CITY OF ALBUQUERQUE

**RE: 13727 Covered Wagon Ave. SE
Grading and Drainage Plan
Engineer's Stamp Date: 01/17/20
Engineer's Certification Date: 01/17/20
Hydrology File: L23D014**

DRAINAGE AND TRANSPORTATION INFORMATION SHEET (REV 6/2018)

ENGINEER'S SEAL	13727 COVERED WAGON	DRAWN BY WCVJ
	GRADING AND DRAINAGE PLAN	DATE 1-17-20 2102007-LAYOUT-1-17-20
1/17/20		SHEET # —
DAVID SOULE P.E. #14522	1606 CENTRAL AVENUE SE SUITE 201 ALBUQUERQUE, NM 87106 (505) 872-0989	JOB # 2102007

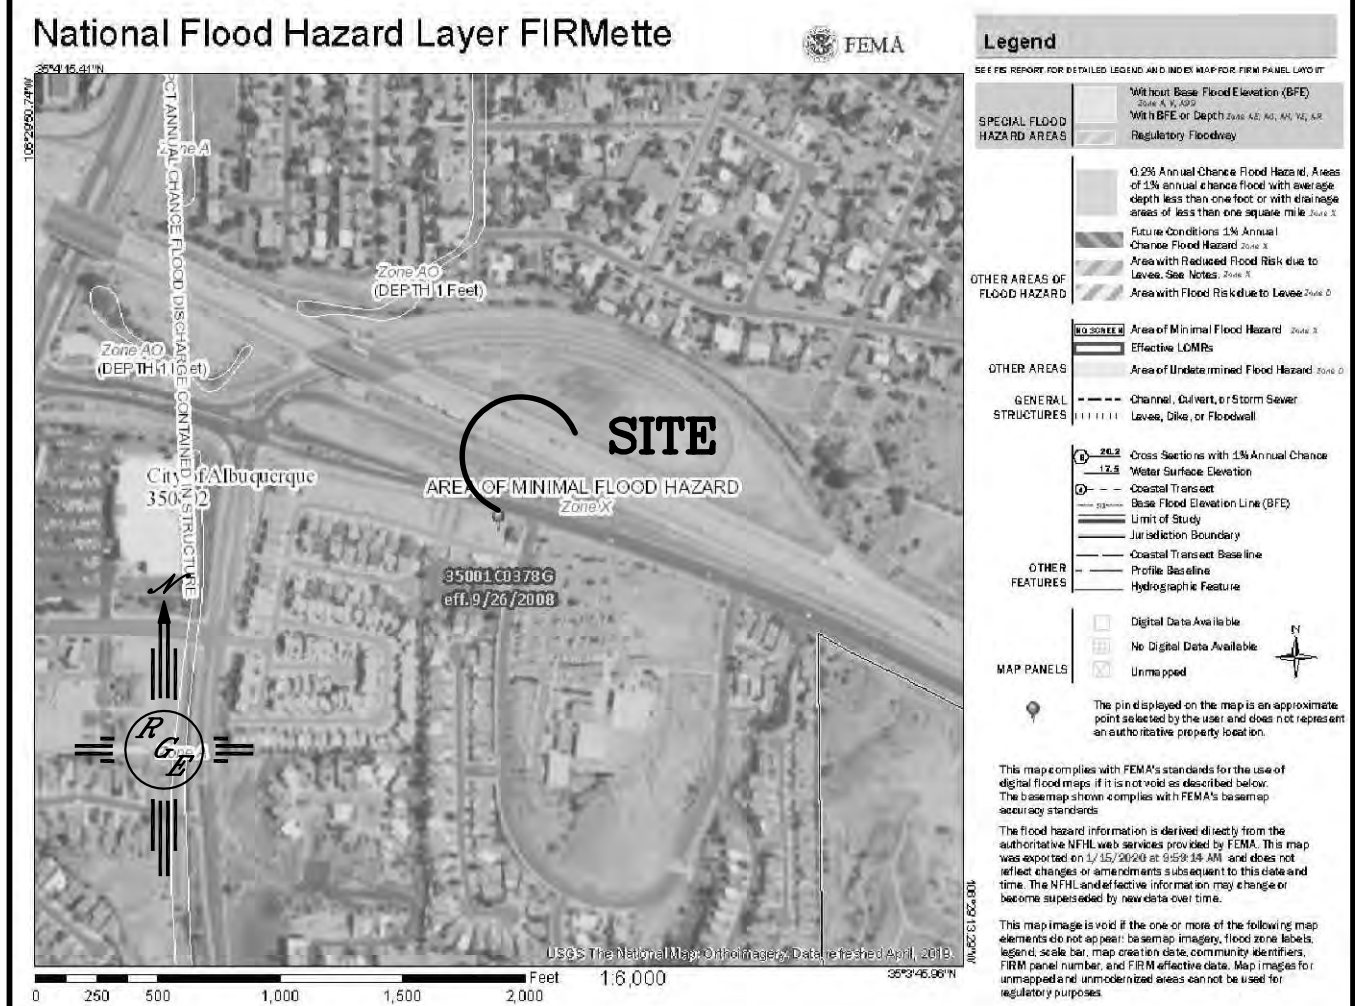
Based upon the information provided in your submittal received 01/17/20, the Grading and Drainage Plan are approved for Building Permit and Building Pad Certification for 13727 Covered Wagon Ave. SE. Please attach a copy of this approved plan in the construction sets for Building Permit processing along with a copy of this letter.

Prior to approval in support of Permanent Release of Occupancy by Hydrology, Engineer Certification per the DPM checklist will be required.
